# SERVICE BULLETIN

## POWER PLANT - ENGINE - INCORPORATION OF MODIFICATION REQUIREMENTS FOR THE EEC FAN HARNESS - CATEGORY CODE 5 - MOD.ENG-71-0055

V2500-ENG-71-0055

Location of the Braided Harness on EEC Fan Harness  
Fig.1

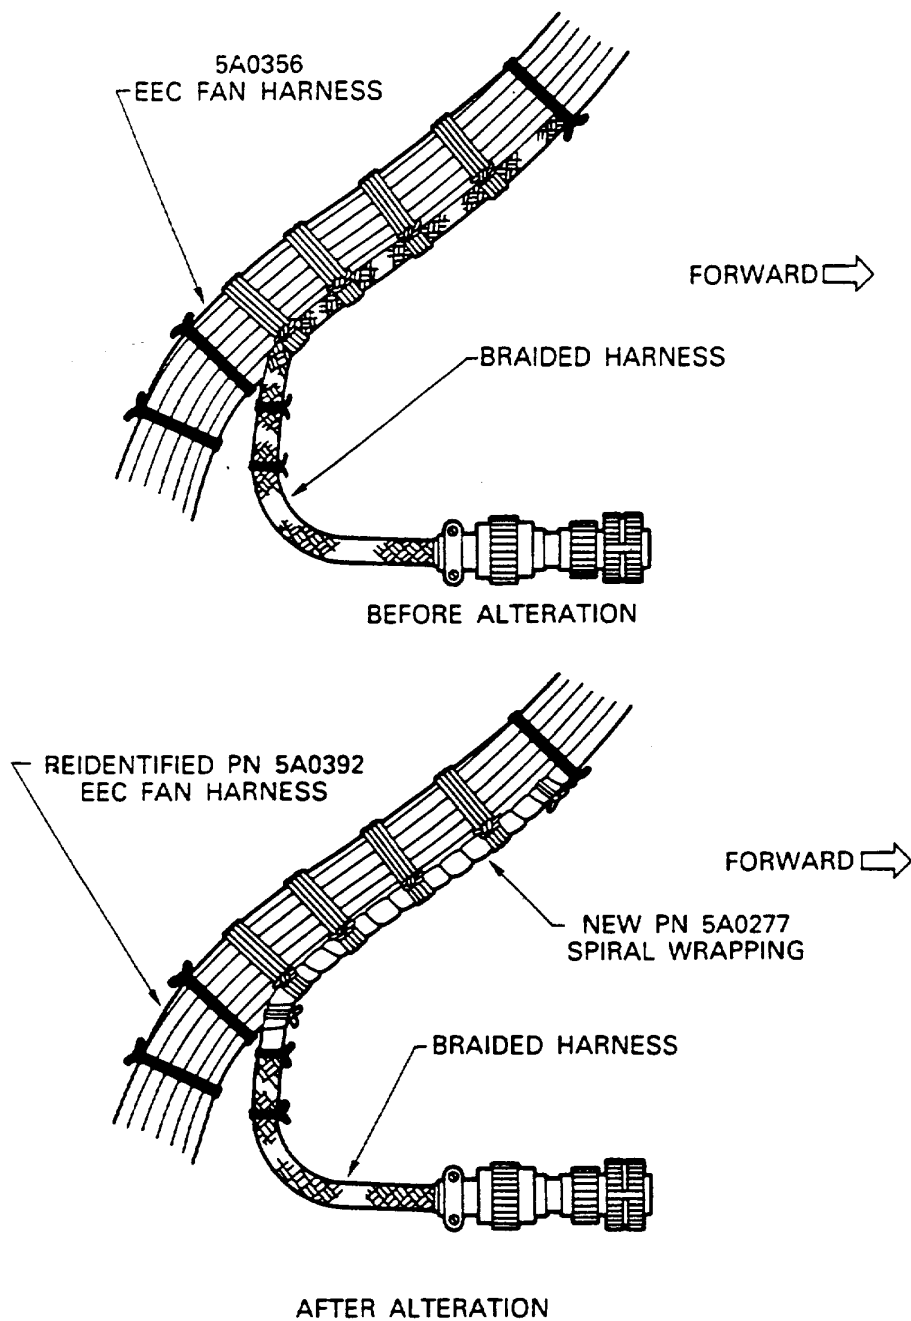
(a) An additional Spiral Wrapping is installed to the braided harness on 5A0356, EEC Fan Harness to prevent chafing to the EEC Fan Harness (See Figures 1 and 2).

Procedure	Supplementary Information	
(1) Find the braided harness on 5A0356, EEC Fan Harness	Refer to Figure 1	
(2) Cut and discard the four Lacing Tapes which safety the braided harness and the main EEC Fan Harness	Refer to Figure 3, Sheet 1

Braided Harness on EEC Fan Harness – Before and After Alteration  
Fig.2

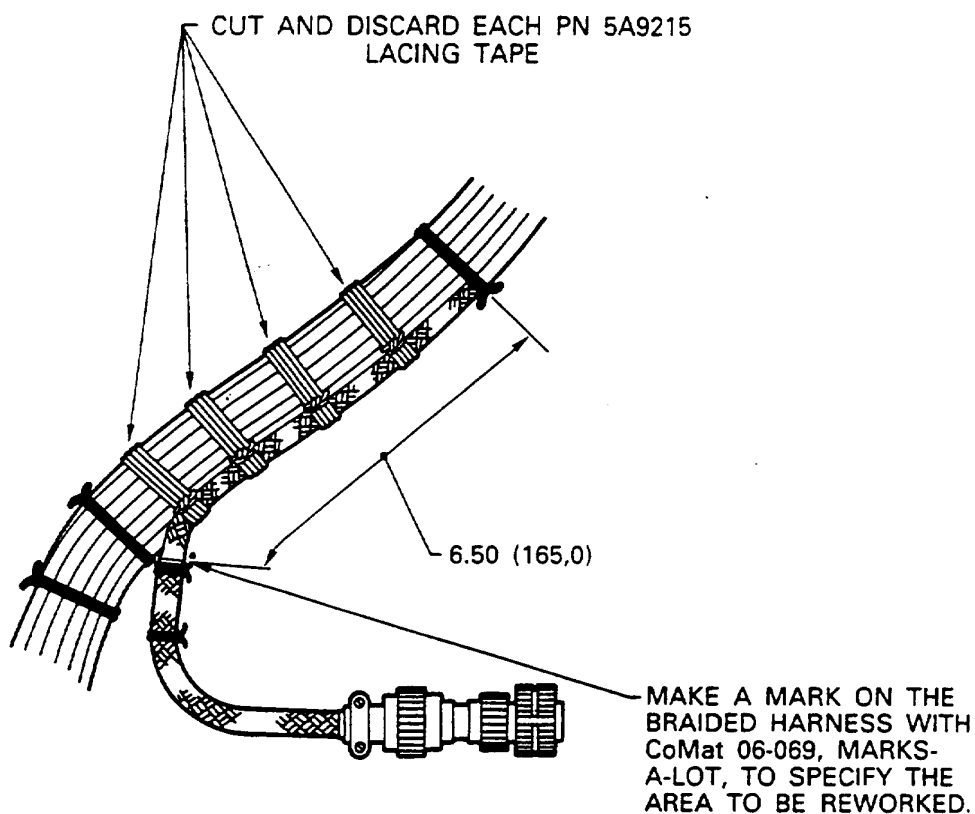
Chafing to the EEC Fan Harness may occur at the bunched area with the oil temperature thermocouple harness for the Air Cooled Oil Cooler.

Rework of the EEC Fan Harness  
Fig.3 (Sheet 1 of 5)

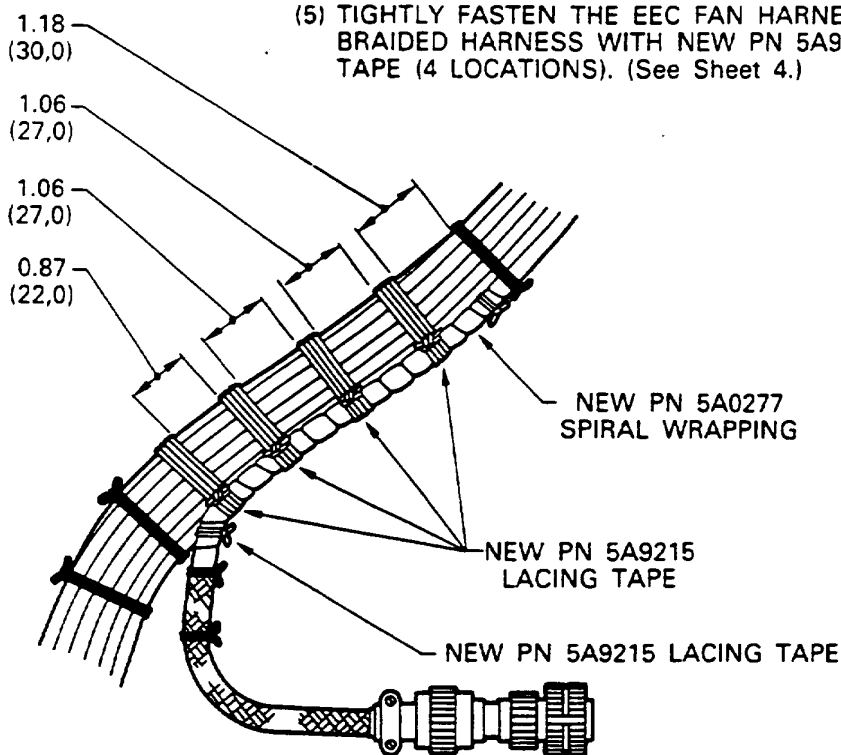
(2) The existing EEC Fan Harness can be reworked to a new configuration (See Figure 3).

(3) Make a mark on the braided harness on 5A0356, EEC Fan Harness, with CoMat 06-069, Marks-A-Lot, to specify the area to be installed the Spiral Wrapping	Refer to Figure 3, Sheet 1, and 1.K.(2)

Rework of the EEC Fan Harness  
Fig.3 (Sheet 3 of 5)

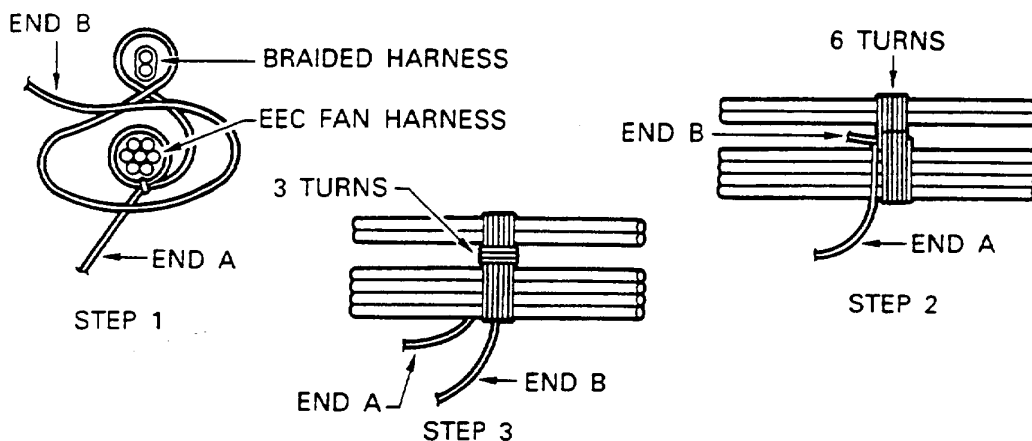
THIS ILLUSTRATION SHOWS A STEP-BY-STEP PROCEDURE  
HOW TO FASTEN EACH END OF THE SPIRAL WRAPPING  
WITH THE LACING TAPE.

NOTE: REQUIRED QUANTITY OF THE LACING TAPE IS  
47.24 in. (1200 mm) TO FASTEN EACH END OF THE  
SPIRAL WRAPPING.

Rework of the EEC Fan Harness  
Fig.3 (Sheet 4 of 5)

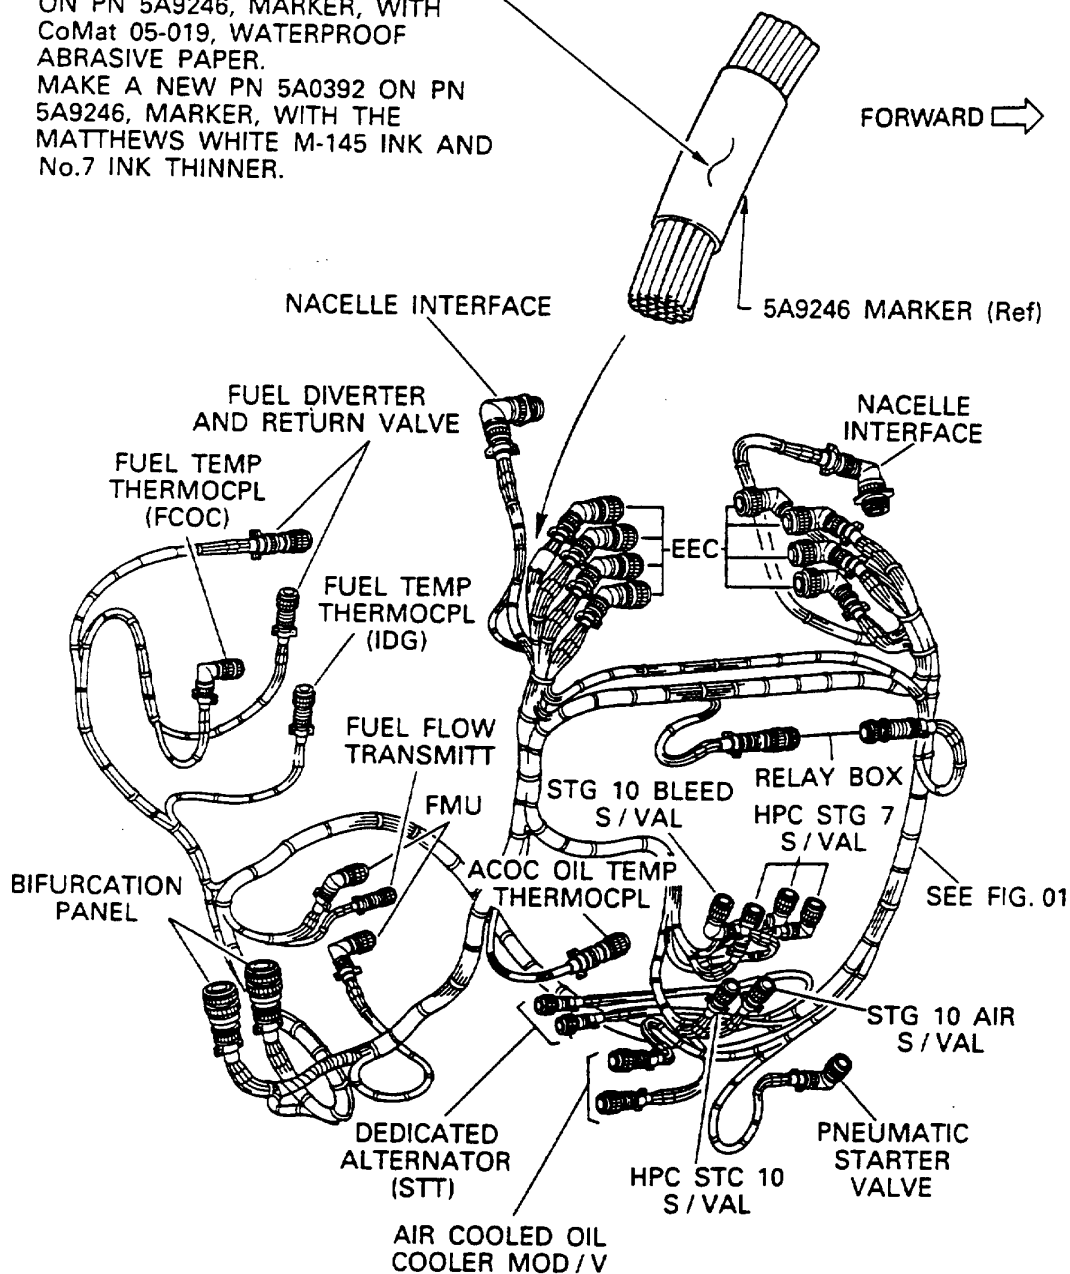
THIS ILLUSTRATION SHOWS THE PROCEDURES HOW TO FASTEN THE EEC FAN HARNESS AND BRAIDED HARNESS BUNCHES WITH THE LACING TAPES.

NOTE: REQUIRED QUANTITY OF THE LACING TAPE AT EACH POSITION IS 47.24 in. (1200 mm) TO FASTEN THE EEC FAN HARNESS AND THE BRAIDED HARNESS.

- o THREAD THE LACING TAPE END "B" BETWEEN THE TWO HARNESSES.
- o WIND THE END "B" AROUND THE BRAIDED HARNESS BY A TURN.
- o THREAD THE END "B" AGAIN BETWEEN THE TWO HARNESSES.
- o PULL THE END "B" TIGHTLY TO MAKE A FIGURE-OF-EIGHT WHIP.

- o REPEAT THE PROCEDURES IN STEP 1 SIX TIMES AND PULL THE END "B" EACH TIME TIGHTLY.
- o TAKE THE END "B" ACROSS THE SIX COMPLETED WHIPPINGS TO THE STARTING POINT OF LACING.

- o WIND THE END "B" TIGHTLY AROUND THE SIX COMPLETED WHIPPINGS BETWEEN THE TWO HARNESSES BY THREE TURNS.
- o PICK UP THE LACING TAPE END "A", AND KNOT THE ENDS "A" AND "B" WITH THE REEF KNOT.
- o CUT OFF THE UNNECESSARY LACING TAPE LEAVING BEHIND TAILS WITH MINIMUM OF 0.31 in. (8,0 mm) AT THE KNOT.
